## **Response to Action Item 3-53 Section 3.2.2**

### **DCD TIER 2, SECTION 3.2.2**

#### **Issue # 7-a (AI 3-53.4)**

Figure 6.3.2-1 Safety Injection / Shutdown Cooling System Flow Diagram (4 of 4)

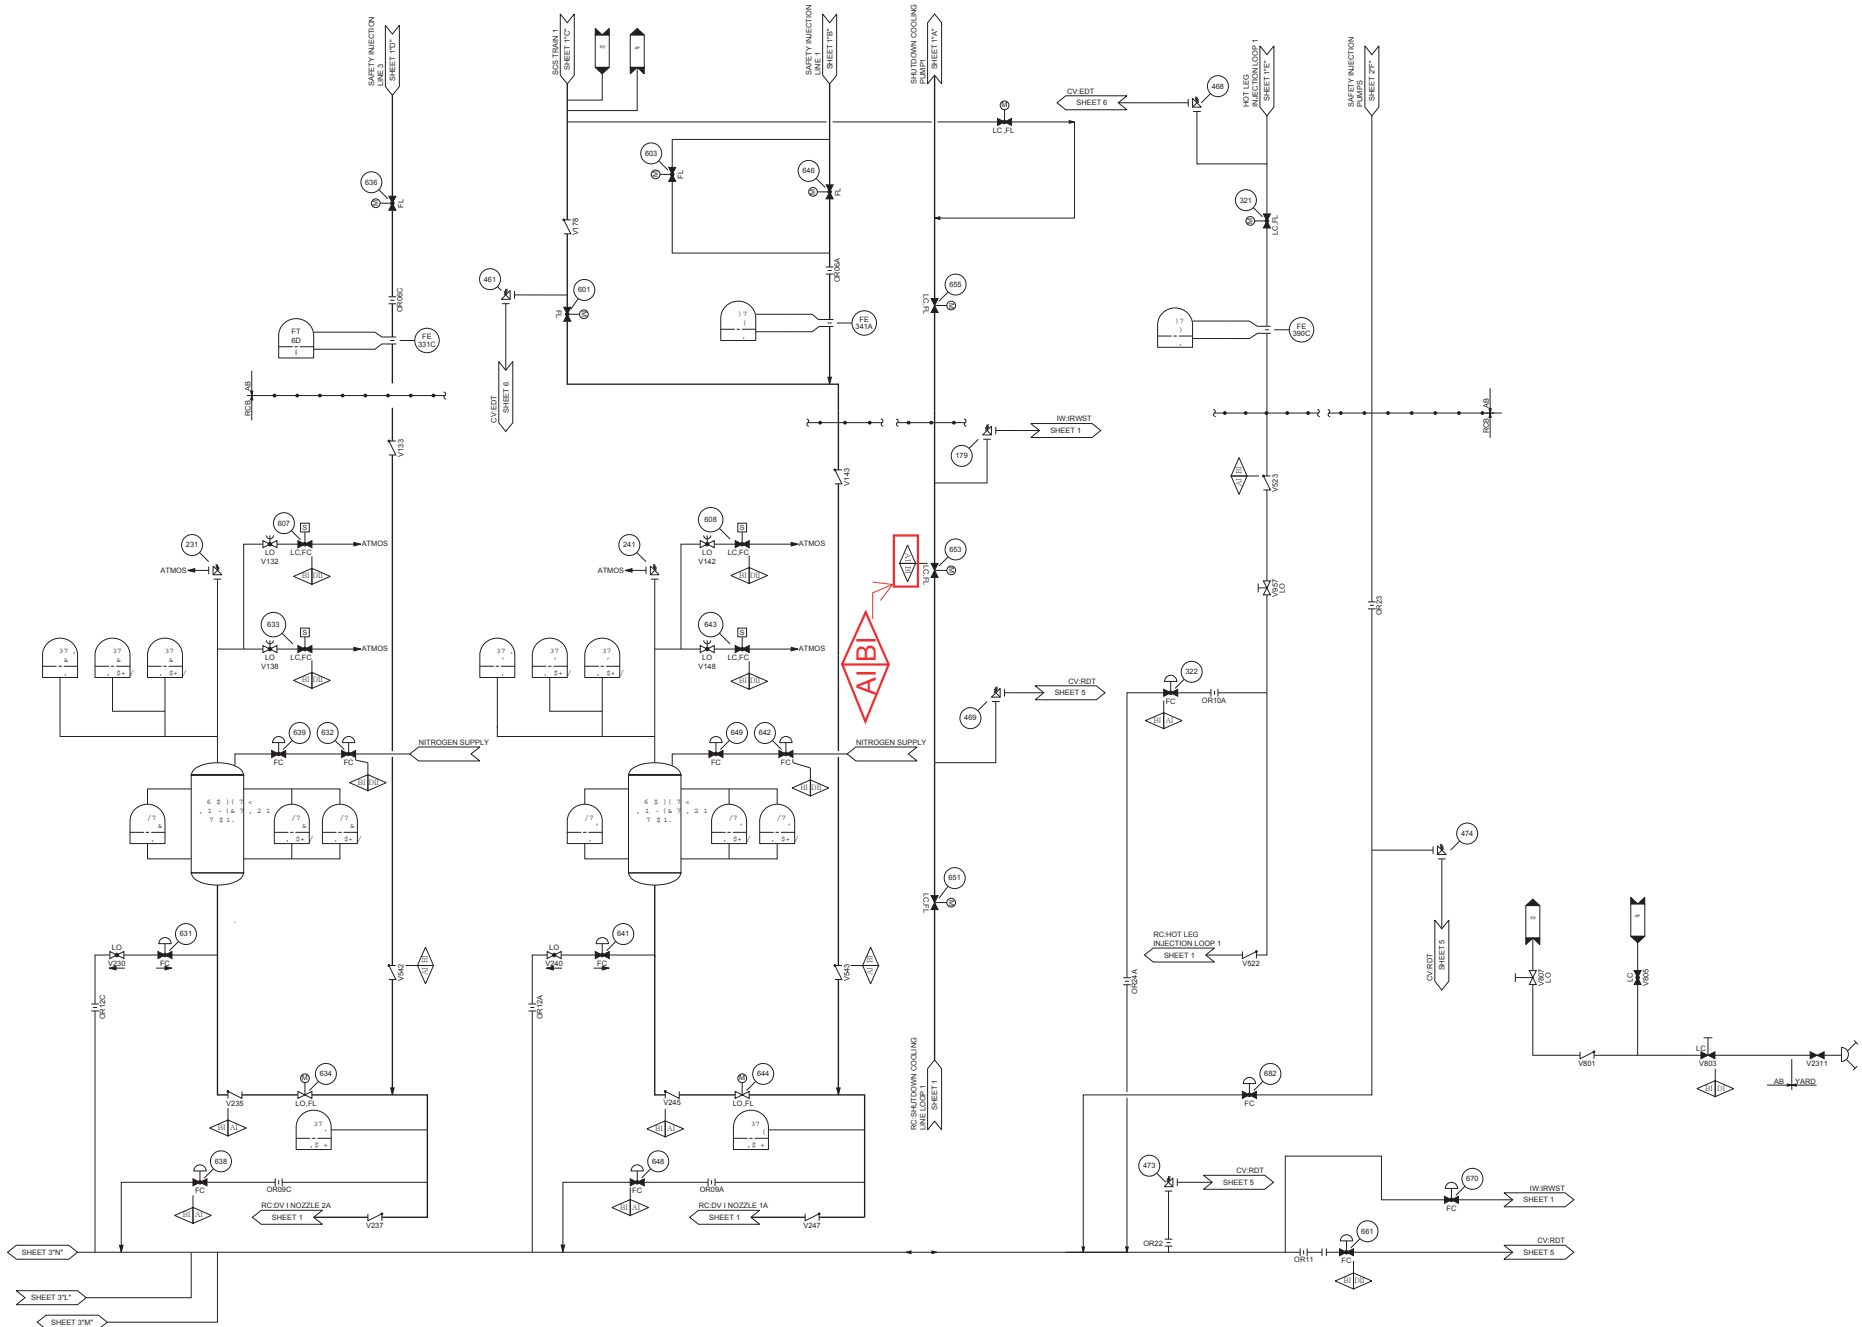
b. DCD Tier 2, page 6.3-63 shows that SI-653 is Quality Group B, while page 3.2-74 shows it as Quality Group A.

SI-653 is Quality Group A. DCD Figure 6.3.2-1 will be updated to correct this error.
